CITY OF CONWAY, ARKANSAS HISTORIC DISTRICT COMMISSION

City of Conway HISTORIC DISTRICT COMMISSION

May 24, 2021

I. Public Hearing Items -Old Conway Design Overlay District

Proposed garage door

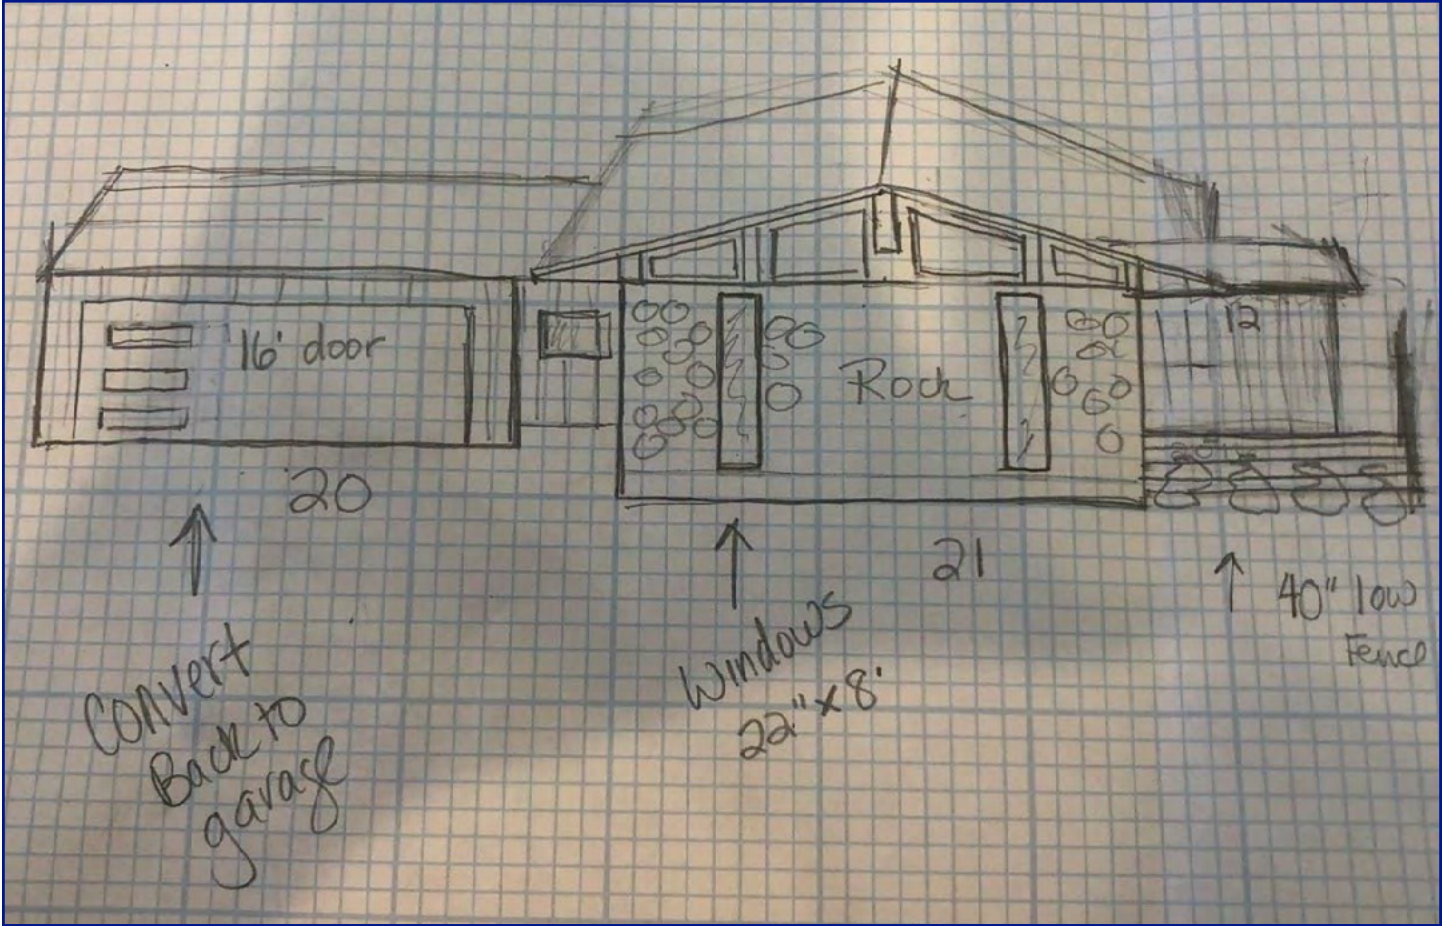
Garages & Outbuildings. The applicant is proposing to convert the attached garage, which was previously enclosed, back to its original state.

The proposed garage door is more modern in design, but given the younger age of the structure the design is acceptable.

Proposed fence location

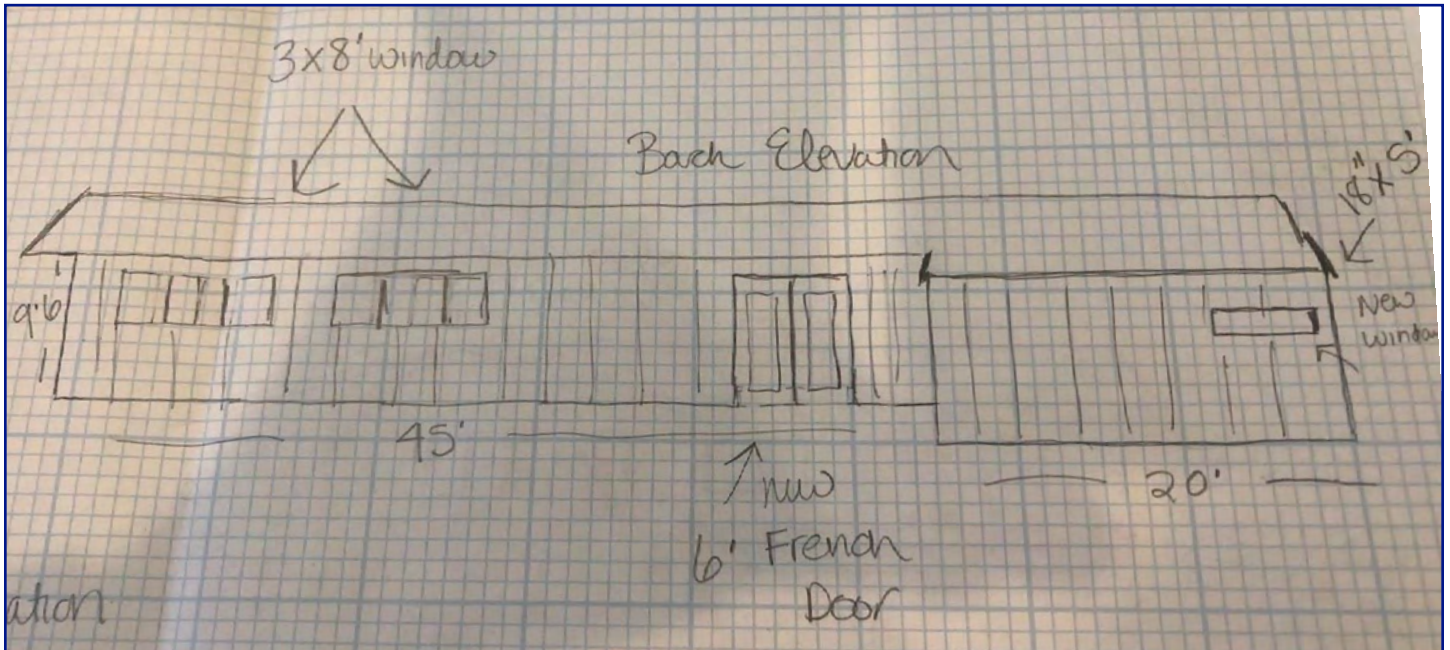
Fences/Walls. Fences may be constructed of wood, iron, brick, or stone. Fences in front yards shall be no more 3.5' tall. *The applicant is proposing a 40" tall wood fence around the patio on the southeast corner of the home which is considered part of the front yard. The proposed fence height and material are appropriate.*

1. Fence height, in the front yard, shall not exceed 42" and shall be of wood.
2. Replacement windows shall be of like-design to existing as per the applicant's proposal.
3. Stone detailing on the front shall remain unpainted.

Proposed windows

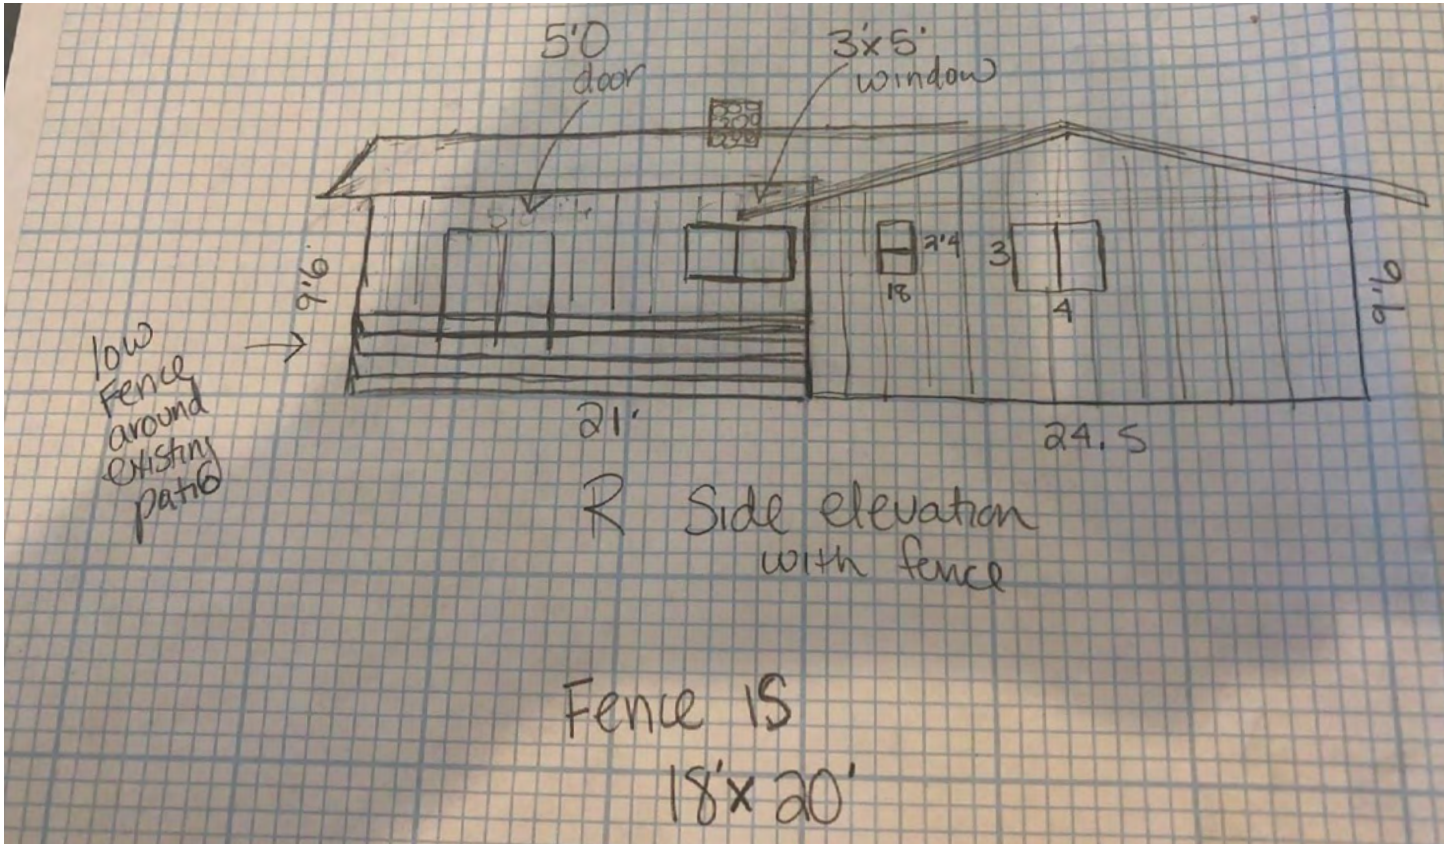
The applicant is proposing to replace all existing aluminum windows with vinyl, replace a section of windows on the rear with French doors, and remove a section of windows and replace with a long transom, to accommodate the master bathroom renovation. The applicant is proposing to replace the windows with a like-design to existing which are primarily horizontal sliding; no divided light windows are proposed. The proposed windows and door design are consistent with the style and age of the residence and therefore appropriate.

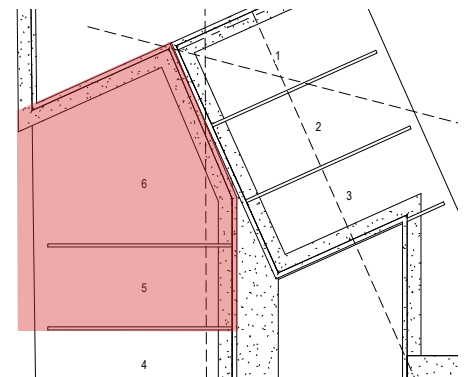
The plans show partial sidewalks on the site. Plans should be revised prior to Development Review application to show sidewalks along both the Scott St and Grove St frontages along the extents of the property to the centerline of the former Oliver St ROW. The applicant may place the sidewalk on private property to accommodate a suitable ADA crossing over the former Oliver St. The sidewalk will need to be placed in a pedestrian easement. This will require removal of two parking spaces along Grove St, as indicated in the image to the right.

1. Provide sidewalks along both the Scott St and Grove St frontages along the extents of the property to the centerline of the former Oliver St ROW. The applicant may place the sidewalk on private property to accommodate a suitable ADA crossing over the former Oliver St. The sidewalk will need to be placed in a pedestrian easement. This will require removal of two parking spaces along Grove St as indicated in the staff report.

1 Site Plan
1" = 10'-0"

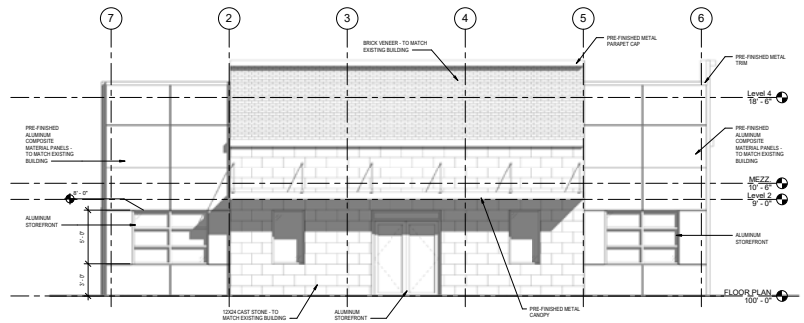
Setbacks and Spacing. Front setbacks are allowed within a range of 6' to 18'. The included drawings indicate a front setback of 10'. The other proposed setbacks conform to the zoning requirements. Side setbacks are encouraged to be narrow to create a higher density, urbanized environment.

Plans do not include any proposed landscaping. Plans should be revised prior to Development Review application to include all required landscaping in accordance with the OCDOD Guidelines and Development Review standards. Additional landscaping of shrubs, to soften the appearance of the existing dumpster enclosure, as well as a continuous row of evergreen shrubs with a mature height of a 1.5' - 4' tall is required to screen the former southern extent of Oliver St and the proposed truck well.

2. The property shall be platted prior to issuance of building permits.
3. In addition to all landscaping required for development review approval, additional landscaping of shrubs to soften the appearance of the existing dumpster enclosure as well as a continuous row of evergreen shrubs with a mature height of a 1.5' - 4' tall is required to screen the former southern extent of Oliver St and the proposed truck well.

1 WEST ELEVATION
1/4" = 1'-0"

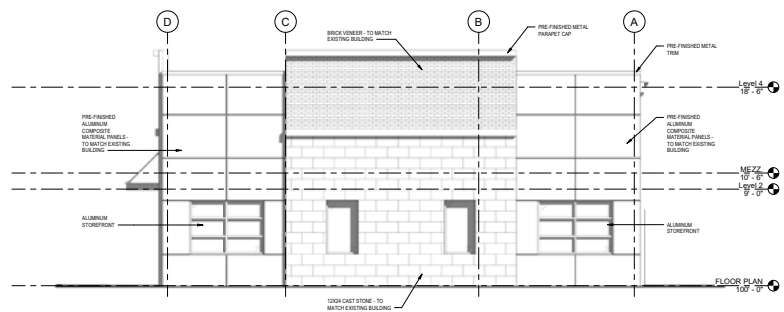
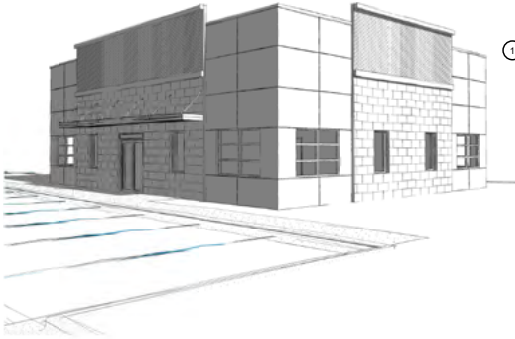
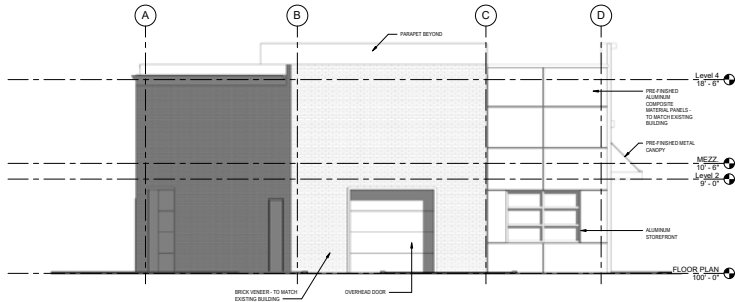
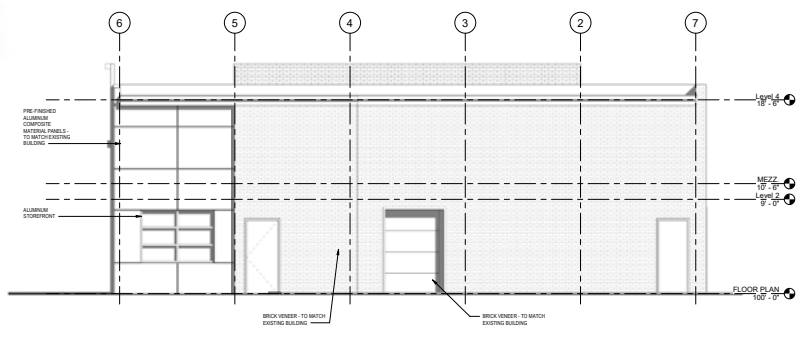
The openings on the front façade, while not totally consistent with all structures in the surrounding area, are consistent with the style and type of structure being built. Voids constitute 12.5% of the Grove St façade and 10% of the Scott St facade.

The front entry will be appropriate. Window designs are appropriate. Recommend requiring two additional windows on the façades of the Grove St and Scott St frontages.

4. Require two additional windows on the façades of the Grove St and Scott St frontages.
5. All mechanical equipment shall be placed in a manner to minimize view from the street, and may be placed rooftop or along a side or rear façade.
